A417 Missing Link
TR010056

8.4 Responses to the Examining Authority's Written Questions (ExQ1)

Responses to the Examining Authority's Written Questions (ExQ1)

Regulation Number:	
Planning Inspectorate Scheme Reference	TR010056
Application Document Reference	8.4
Author:	A417 Missing Link

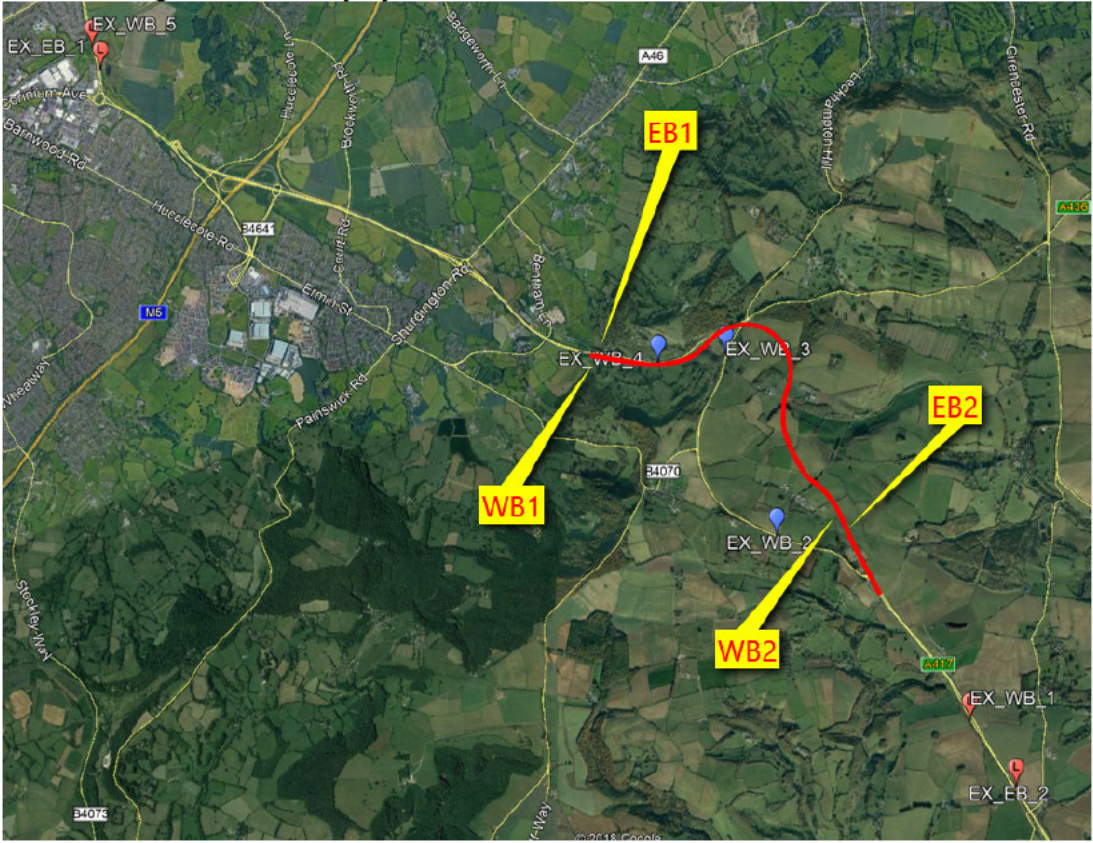
1.11.17	Applicant	<p>Abnormal Indivisible Loads (AILs)</p> <p>The Transport Report does not directly reference movements of AILs. Is it the case that none are anticipated or needed to facilitate construction of the Proposed Development?</p>	<p>The Road Vehicles (Authorisation of Special Types) (General) Order 2003 defines an abnormal indivisible load as:</p> <p><i>a load that cannot without undue expense or risk of damage be divided into two or more loads for the purpose of being carried on a road and that—</i></p> <p><i>(a) on account of its length, width or height, cannot be carried on a motor vehicle of category N3 or a trailer of category O4 (or by a combination of such vehicles) that complies in all respects with Part 2 of the Construction and Use Regulations; or</i></p>

Number	Directed to	Question	Applicant's Response
			<p><i>(b) on account of its weight, cannot be carried on a motor vehicle of category N3 or a trailer of category O4 (or by a combination of such vehicles) that complies in all respects with—</i></p> <p><i>(i) the Authorised Weight Regulations (or, if those Regulations do not apply, the equivalent provisions in Part 4 of the Construction and Use Regulations); and</i></p> <p><i>(ii) Part 2 of the Construction and Use Regulations.</i></p> <p>Part 2 of the Road Vehicles (Construction and Use) Regulations 1986 defines the dimensions of the vehicles.</p> <p>Our interpretation of the regulations is based on the government guidance on 'Transporting abnormal loads', available on the Government website, which states that: An 'abnormal load' is a vehicle that has any of the following:</p> <ul style="list-style-type: none"> • a weight of more than 44,000kg • an axle load of more than 10,000kg for a single non-driving axle and 11,500kg for a single driving axle • a width of more than 2.9 metres • a rigid length of more than 18.65 metres <p>Based on this interpretation, Abnormal Indivisible Loads (AILs) are anticipated to be required to facilitate the construction of the scheme, where the bridge beam lengths are greater than 18.65m or wider than 2.9m.</p> <p>Steel girders are likely to be spliced and connected on site rather than transported as a single element. However, some elements must be transported whole such as Shab Hill junction beams (approximately 19m), and Cotswold Way crossing deck (approximately 5m wide).</p> <p>Based on the preliminary design, AIL's are likely to be required for the Cotswold Way Crossing and Shab Hill underbridge. However, the design does not include any structural elements that are unusual for a scheme of this type and it is anticipated that during detailed design, the designer, contractor, and fabricator will collaborate to define a solution that minimises the amount of AILs required</p> <p>Where AILs are required, the contractor will adhere to the guidance set out by National Highways in the 'Notification requirements or the movement of abnormal indivisible loads or vehicles' guidance document.</p>

Number	Directed to	Question	Applicant's Response
			<p>All AILs would be detailed and secured by the Construction Traffic Management Plan as part of the EMP (Construction stage) which will be prepared to cater for all movements to and from the scheme.</p> <p>Where AILs are required, they will be transported via the strategic road network and as such we do not anticipate any environmental impacts, which is why they have not been assessed.</p>
